# Flash Memory Board

Sheet: /  
 File: CTS-Flash-Memory-Breakout.kicad\_sch

**Rev: rev1**

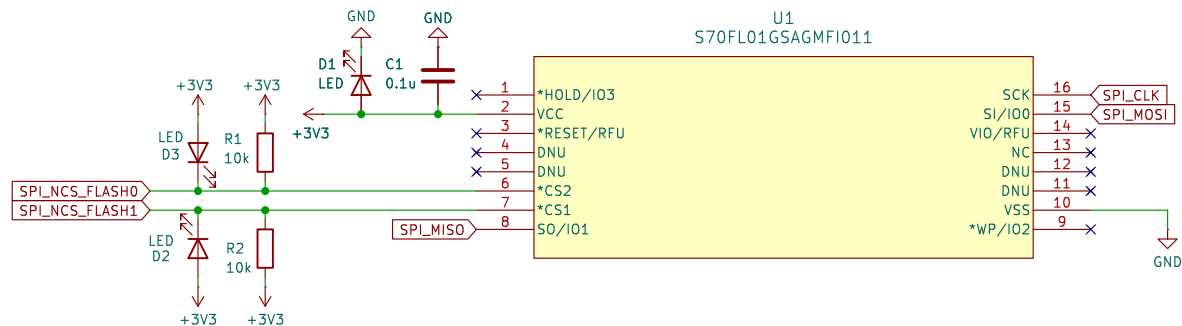
FIXME: LEDs need inline resistors (rev1 errata)  
 FIXME: GND should point down, 3V3 should point up  
 FIXME: CS net/silkscreen labels should match the CS1/CS2 labels on S70 symbol
